# BOARD OF WATER SUPPLY

Subject: Honolulu Board of Water Supply (BWS) Comments on the Navy's Conceptual Site Model (CSM), Investigation and Remediation of Releases and Groundwater Protection and Evaluation, Red Hill Bulk Fuel Storage Facility (RHBFSF) Revision 1 dated June 30, 2019

Figure 5 Water level contours interpolated from water levels measured at 2/05/2018 after pumping as usual and Halawa Shaft has not been pumping. Arrow indicated the implied groundwater flow directions based on groundwater elevation contours

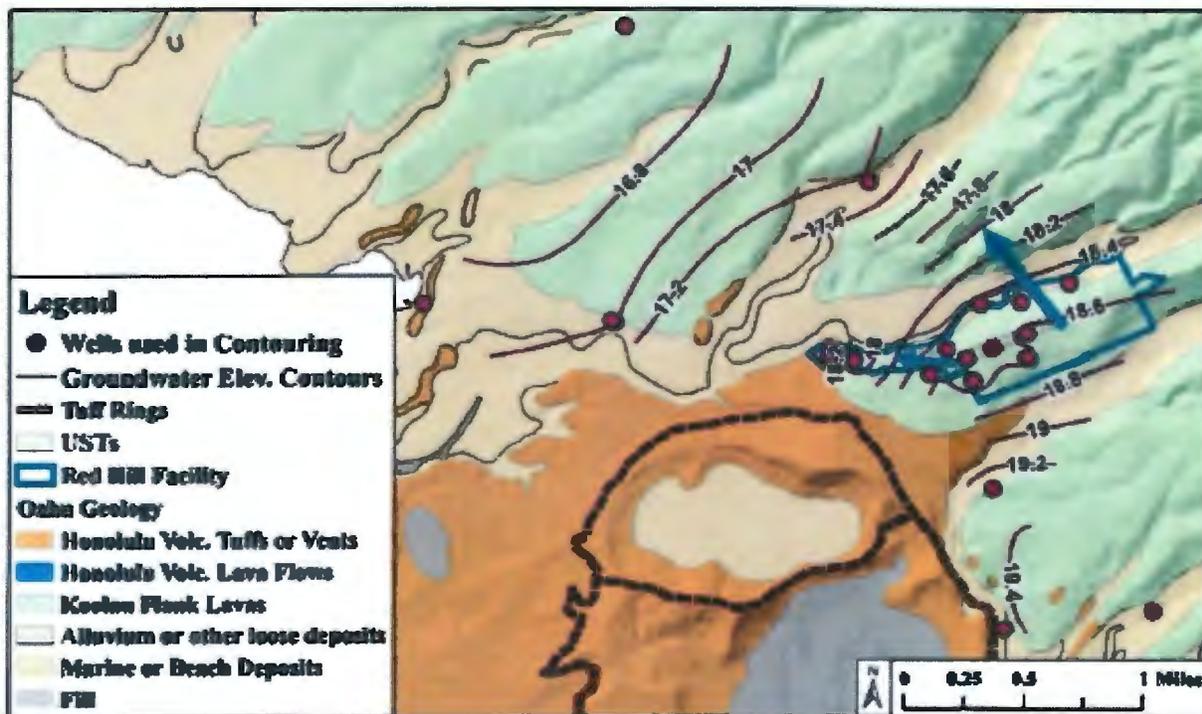
Figure 5 was generated by the DOH and includes a greater area and a different set of contour intervals. Figure 5 demonstrates that the Navy's presumption that groundwater flow in the vicinity of the RHBFSF is from mountain (mauka) to ocean (makai) is not supported by the measured water levels. In its discussion of the hydraulic gradients, the DOH acknowledges that other modeling studies have also assumed mauka to makai flow in the Red Hill area. However, after their review of the measured water level the DOH states:

"The groundwater elevation contours beneath the Red Hill Ridge and beneath the Halawa-Aiea area indicate that at least where the penetration of the saprolite into aquifer is either shallow or non-existent, the relative groundwater elevations indicate groundwater flow to the northwest. More specifically, the groundwater contouring strongly suggests that the flow direction beneath the upper part of the facility is to the northwest. This observation is in direct contrast to the Navy's expectation that the water flows along the shortest mauka to makai path from the high elevation recharge areas to the coast" (DOH, 2019a).

It is clear to the BWS and consistent with comments from the Regulatory Agencies that the available evidence simply does not support the Navy's mauka to makai only groundwater flow regime. Despite all the analysis and data that has been presented to the Navy on this issue since its last CSM iteration, the revised CSM still does not appear to consider this information and does not meaningfully discuss any alternative conceptual models for the groundwater flow system. This is a critical flaw that undermines the Navy's entire analysis.

Figure 6. Location and hydraulic properties associated with Clinker Zone depicted in the Navy's Conceptual Clinker Model (modified from slide presented by the Navy on March 16, 2018 during Groundwater Modeling Working Group Meeting No. 9)

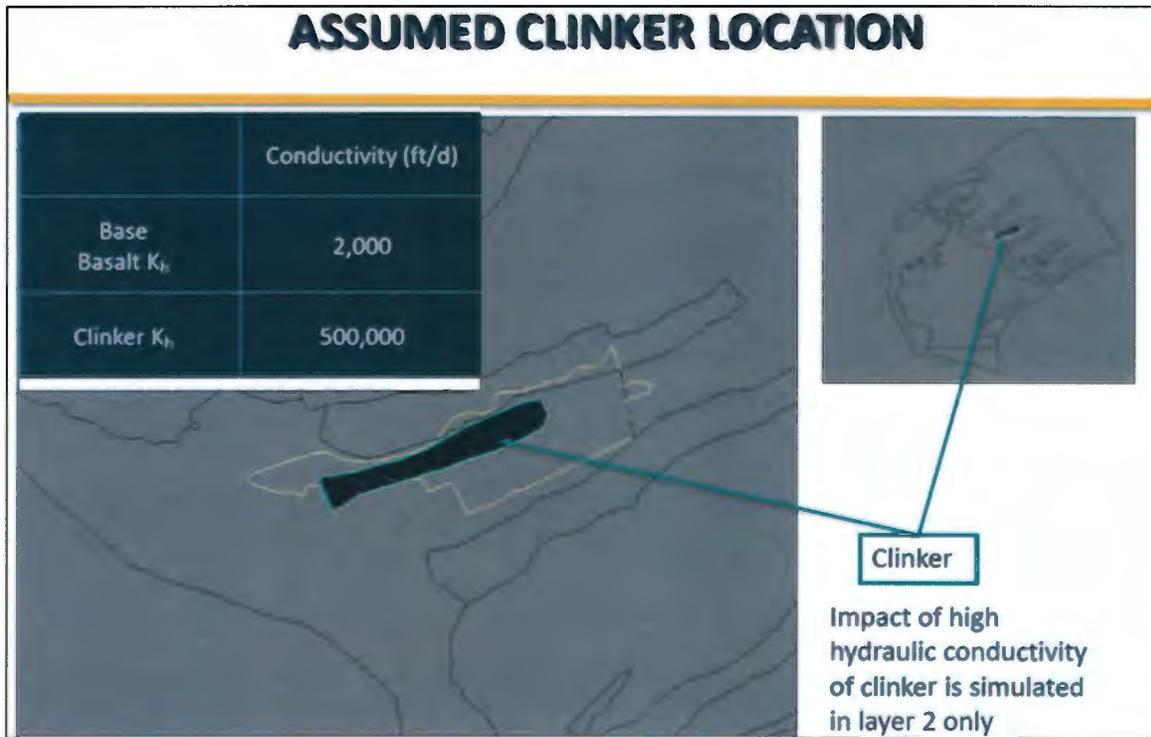
During Groundwater Modeling Working Group Meeting No. 14 (March 2019) the Navy stated that it would continue with a clinker-zone model and will also construct a “heterogeneous” model. The results of the Navy's clinker-zone model are cited throughout the revised CSM and were presented in a November 2018 Honolulu City Council meeting to demonstrate the Navy's interim model is adequately predicting groundwater levels. As previously discussed by BWS, the Navy's clinker-zone model and its simulated water levels is physically implausible and

The clinker model scenario is shown in Figure 6, a sole clinker is located within only model layer 2 and within a narrow lateral zone that is aligned with the location of the fuel tanks and provides a connection to Red Hill Shaft. The dip angle and thicknesses required to create the clinker realization in Figure 6 is physically unrealistic and incompatible with the CSM data included as part of the geological cross-section shown in Figure 7. To generate a flat hydraulic gradient the hydraulic conductivity of the clinker was set to 250 times greater than the basalt. Figure 8 shows the flat hydraulic gradient simulated by the clinker-zone model. The contours show that the hydraulic gradient is toward the middle of the topographic ridge, which is the opposite direction of the measured hydraulic gradient (also see Figures 2 and 3) (BWS, 2018d).

Figure 7. Mapped Basalt Zones showing dipping clinker zones in the vicinity of Red Hill Shaft and monitoring wells RHMW01 and RHMW02 (DON, 2018a Figure 5-2).

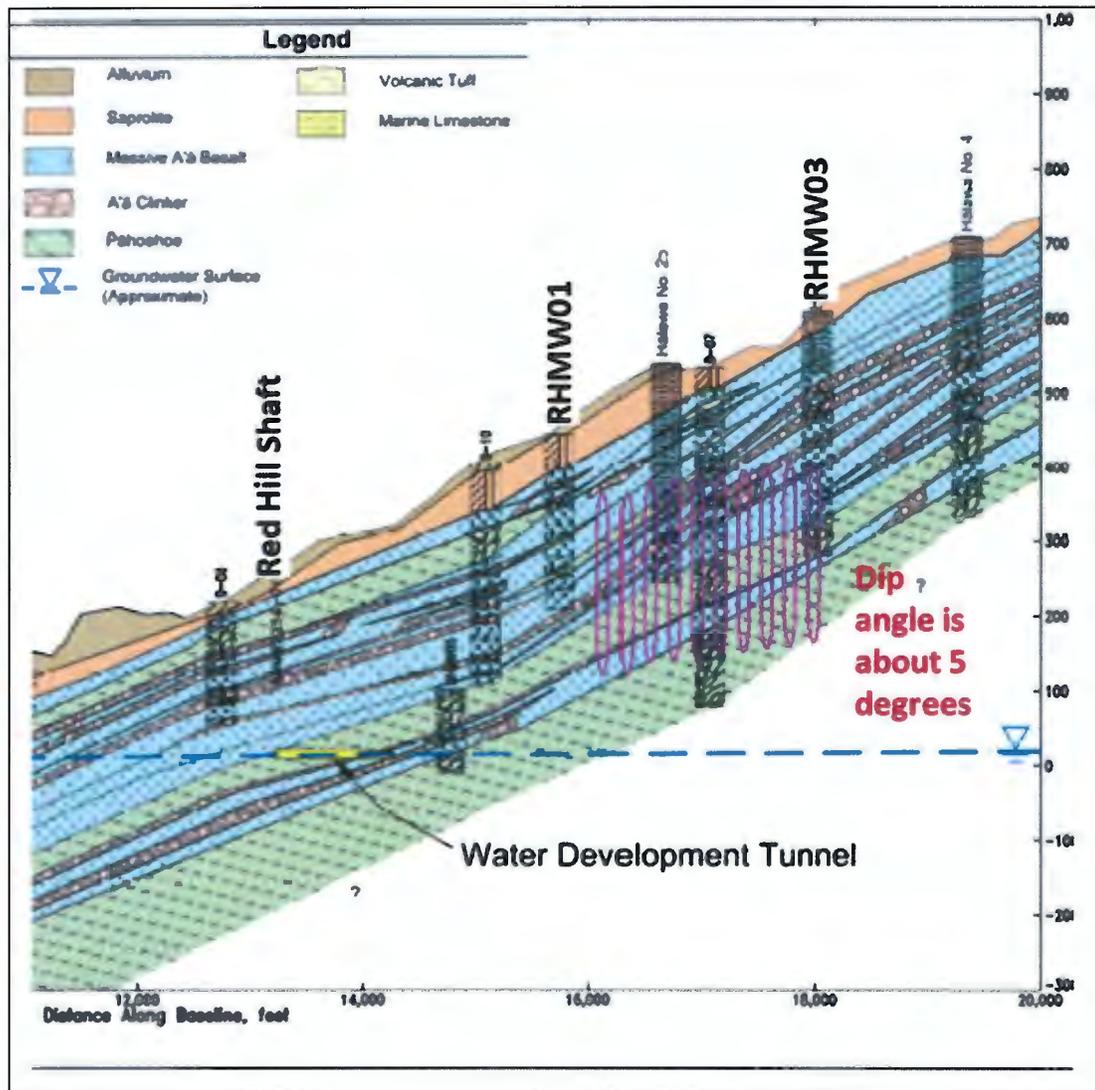
be considered as a viable model (BWS, 2019). While the BWS acknowledges that clinker zones represent preferential flow paths, there is no geological evidence that indicates that a single clinker zone connects the shallow groundwater flow zone beneath the tanks to Red Hill Shaft as presumed by the Navy's clinker-zone model. The revised CSM does not provide any geologic information from either the tank barrel logs or the monitoring well drilling logs to model a clinker zone as shown in Figure 6. Moreover, this model is inconsistent with available data that indicates thin clinker zones dip through multiple layers and are interconnected vertically by fractured basalt.

Figure 8 Simulated hydraulic heads produced by the Navy's Conceptual Clinker Model (modified from slide presented by the Navy on March 16, 2018 during a Groundwater Modeling Working Group Meeting No. 9)

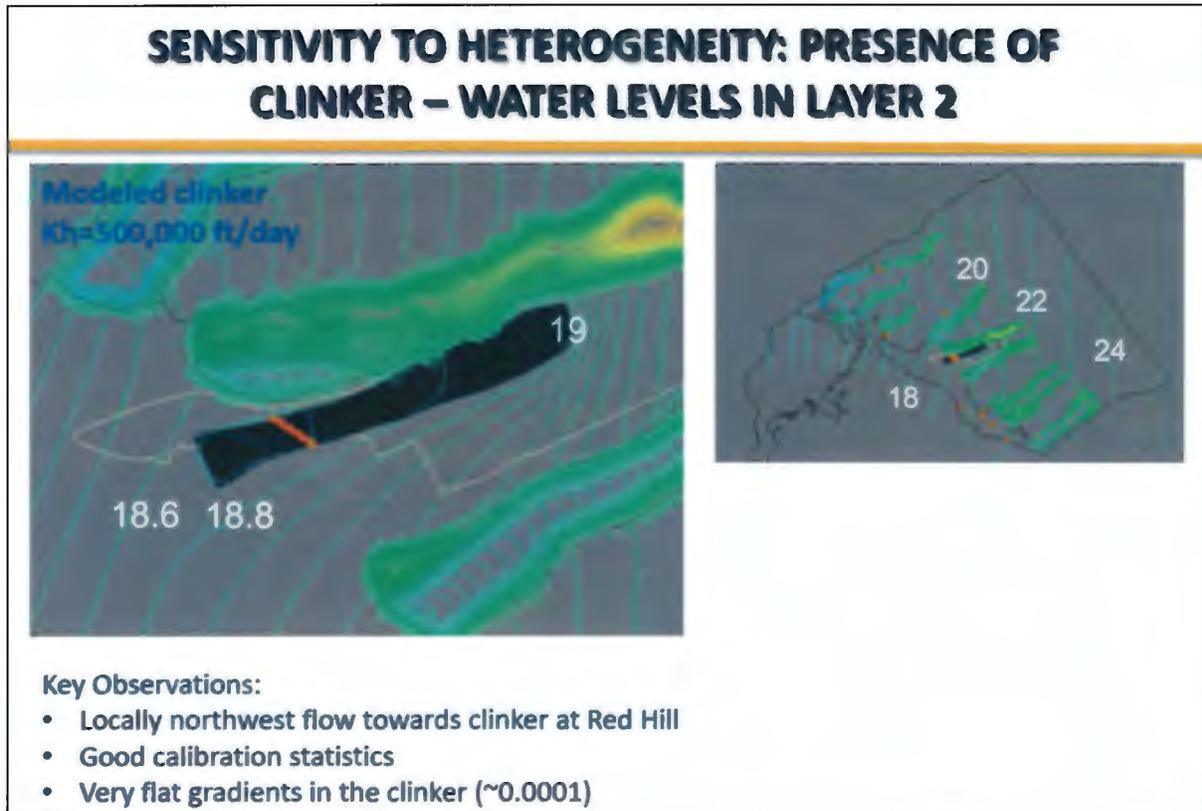
Neither the Navy's revised CSM nor its groundwater flow model can be relied upon to support a TUA decision. Moreover, the CSM cannot be considered to be complete unless and until the CSM provides, at a minimum, the geologic framework used to guide and constrain the location, size, and orientation of clinkers as well as the type and amount of aquifer heterogeneity ultimately incorporated into the Navy's groundwater flow model. The Navy's clinker-zone model does not satisfy this concern. To the contrary, the Navy's clinker-zone model and its simulated water levels is physically implausible and inconsistent with field data and, therefore, should not

The BWS recommends that the Regulatory Agencies require the Navy's CSM to include a detailed description of the Navy clinker-zone model because it is used to calculate biodegradation rates from measured concentration values in wells. The BWS also recommends that the Regulatory Agencies consider the CSM to be incomplete until it is modified to include hydrogeological constraints to guide the development of groundwater flow models to represent preferential flows and/or heterogeneity in the saturated basalt in the RHBFSF. The Navy should not be allowed to rely on the groundwater modeling for any decision unless and until it completes this analysis.

Figure 9 Estimated depth to which saprolite extends to the freshwater aquifer expressed as the percent of the total aquifer

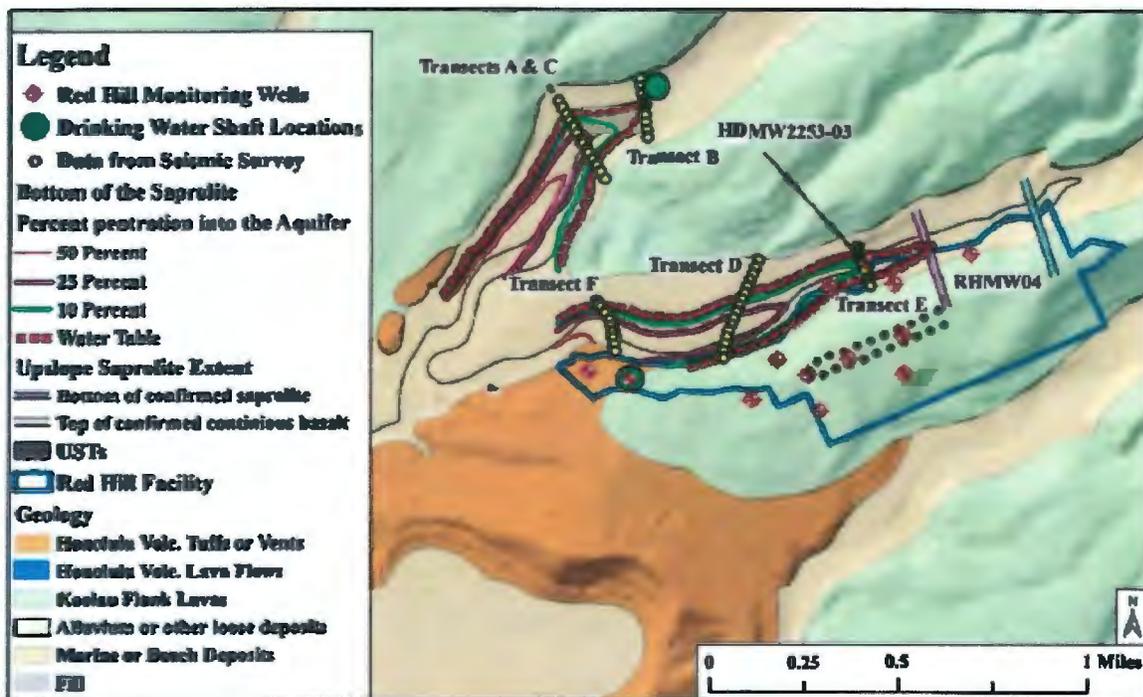
The DOH used the six transects (shown in Figure 9) to calculate the slope of the basalt/saprolite interface. Its analysis of these six transects demonstrates that, except for the region between Transect F and Transect D, the dip angle for the basalt/saprolite interface is much greater than the 3% slope assumed by the Navy. In fact, the DOH analysis indicates that the dip angle for

the basalt/saprolite is 9.1% between Transect D and Transect E in South Halawa Valley and is 24% between Transect A and Transect B in North Halawa Valley.

Based on the findings from the EPA and DOH analysis of the seismic data (EPA and DOH, 2018; DOH, 2019b), the BWS recommends that the Regulatory Agencies require the CSM be considered incomplete until it is modified to include a similar evaluation as performed by the DOH and hydrogeologic constraints to guide the development of saprolite/basalt boundary in South Halawa and North Halawa valleys.

Figure 10 Result from a field study presented by EPA and DOH on August 15, 2018 that shows that there is not a correlation between temperature change in the vadose zone and the presence of LNAPL

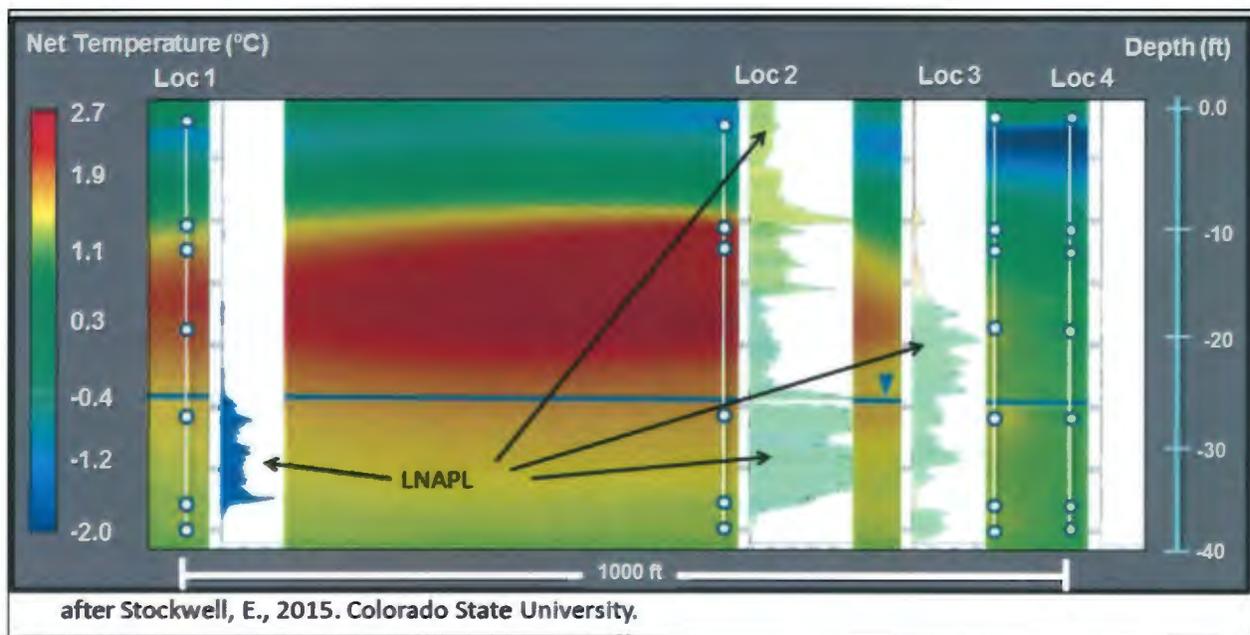
The Navy's revised CSM has not addressed previous comments regarding the Navy's underlying assumption that an increase in the temperature profile can be used to determine the vertical distribution of LNAPL in the vadose zone. The Navy makes this assertion without offering sufficient evidence to establish the relationship. The BWS (BWS, 2018a), EPA, and

"A net positive temperature profile indicates the effects of exothermic biologic reactions and is affected by a variety of subsurface factors. In general, that relationship can be useful to infer lateral distributions of LNAPL biodegradation but is highly uncertain with respect to the LNAPL vertical distribution. In many cases, as shown in the example thermal profile in our August 15, 2018 presentation (reproduced as Figure 10), the LNAPL vertical mass distribution cannot be inferred from the temperature profile. A review of data in the 2007 Red Hill investigation report (DON, 2007) shows that the rock cores were evaluated at well RHMW02 for evidence of petroleum contamination by checking for odor and by screening with a photo-ionization detector. No evidence of petroleum contamination was found" (EPA and DOH, 2018).

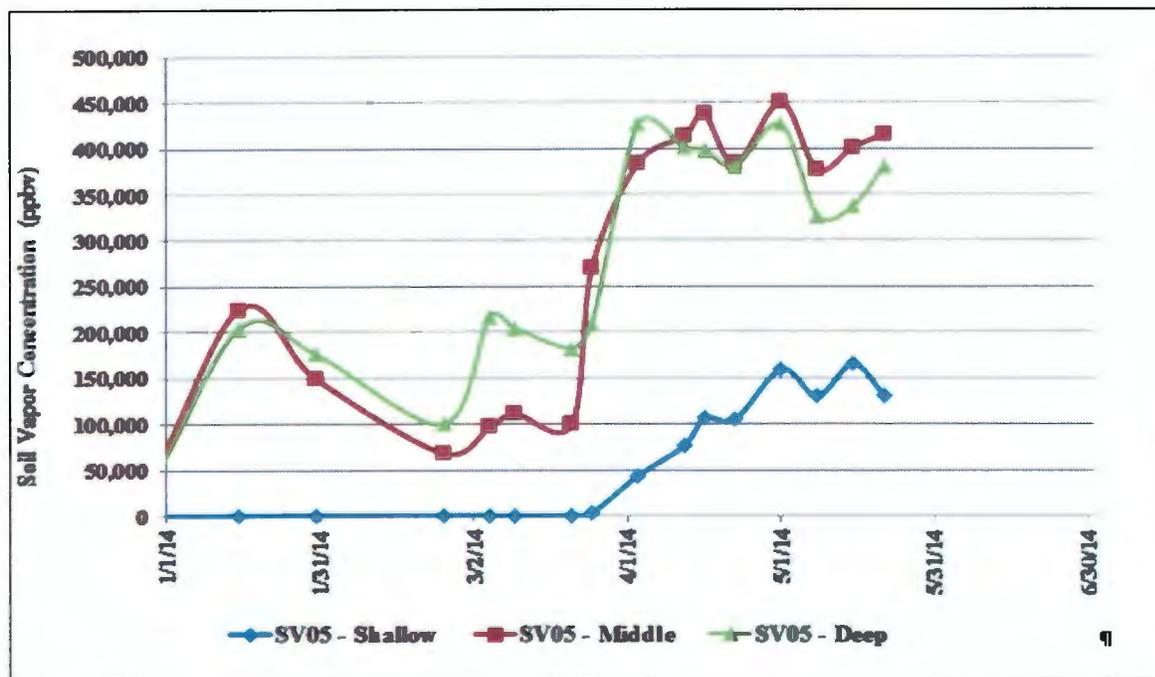
- The third reason is that in-situ vapor probe responses around Tank 5 in the timeframe following the 2014 release can be interpreted as indicating that the primary vapor migration may have been to the northwest side of that tank and not in the direction of RHMW02 (see Figure 11). Actual LNAPL transport outcomes beneath Tank 5 in 2014 below the vapor probes is unknown; the conservative assumption based on this limited data is that transport was potentially to the northwest and is not represented with any certainty by the spatially limited monitoring well array.

The BWS continues to have serious concerns regarding the Navy's analysis of the thermal data and recommends that the entire section of the revised CSM report related to the Navy's thermal analysis be omitted as not technically defensible. Because the fate of fuel from the Tank 5 spill is of paramount importance to the conceptual model for LNAPL migration, the BWS

recommends that the Regulatory Agencies require the CSM be considered incomplete until the Navy has fully addressed both BWS and Regulatory Agency concerns regarding the validity of its thermal analysis.
